Aide Ortiz - Kaweah River Rock revised NPDES permit

Re: Responses to Comments and Revised Tentative Waste Discharge Requirements
Santa Fe Aggregates, Inc. Kaweah River Rock Sand and Gravel Plant (NPDES
No. CA0082201)

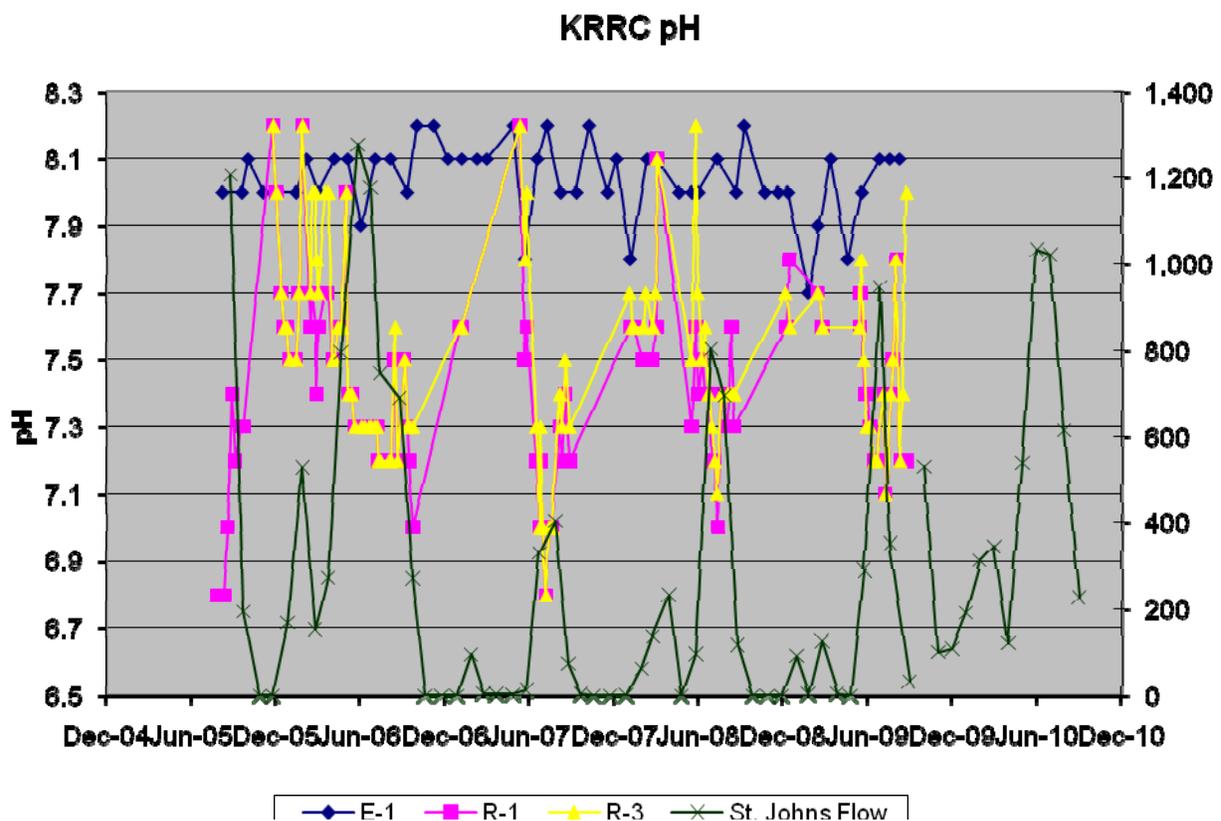
normal, or “ambient”, conditions in the St. Johns River, consistent with the response prepared by Board staff. The comment also presented data that clearly demonstrates that pH variations between the upstream monitoring location (RSW-001, formerly identified as R-1) and the downstream monitoring location (RSW-002, formerly identified as R-3) vary by more than 0.3 pH units and that this variation cannot be caused by the discharge from the Kaweah River Rock facility. The data chart from our original comments is reproduced here for convenience.

As shown on the chart, above, in late May 2007 the pH measured at R-1 was 7.6 and the pH measured at R-3 was 8.0, a change of 0.4 pH units. The pH of the effluent was 7.8 pH units. The flow in the river at that time was 13 cfs while the discharge was 0.4 cfs. Independent of the magnitude of flow and the degree to which any mixing may have occurred between the effluent point and R-3, located 1800 feet downstream, it is chemically impossible for the effluent at a pH of 7.8 to change the receiving water from a pH of 7.6 to a pH of 8.0. The discharge has clearly not created a condition that has caused or threatened to cause a potential violation of the Permit. It is, as stated by Board staff, part of the expected ambient variability within the St. Johns River.

Likewise, in February and March 2006, there were three occasions when the pH measured at the upstream location, R-1, was 7.6 and the pH measured at the downstream location, R-3, was 8.0. At that same time, the pH in the effluent was 8.0. Flow in the river was reported at 152 cfs while the discharge was 0.88 cfs. Staff is correct in stating that Santa Fe has not conducted a mixing zone analysis. However, unless the water sampled at R-3 was effectively 100 percent effluent from the Plant, a discharge of 0.88 cfs at a pH of 8.0 could not possibly change the pH of the river, flowing at 152 cfs, from 7.6 to 8.0. To assume that there would be no mixing over a distance of 1800 feet is unfounded. As with the situation discussed in the paragraph above, these three measurements are clearly not a condition that has caused or threatened to cause a potential violation of the Permit.

Based on this more detailed presentation of the pH data, Santa Fe respectfully requests that Board staff reconsider their decision to maintain that the effluent has caused or threatened to cause a violation of the pH standard. The data and site conditions clearly demonstrate that the pH variations cited are part of the normal ambient variation in the receiving water within the St. Johns River, as acknowledged by Board staff in their response to our initial comment. In addition, given the documentation that the natural ambient changes within the river result in pH differences that are greater than 0.3 pH units between the upstream and downstream receiving water sampling locations, it would be appropriate to acknowledge this condition in the permit and either remove or clarify the 0.3 pH-unit receiving water limitation V.A.9.
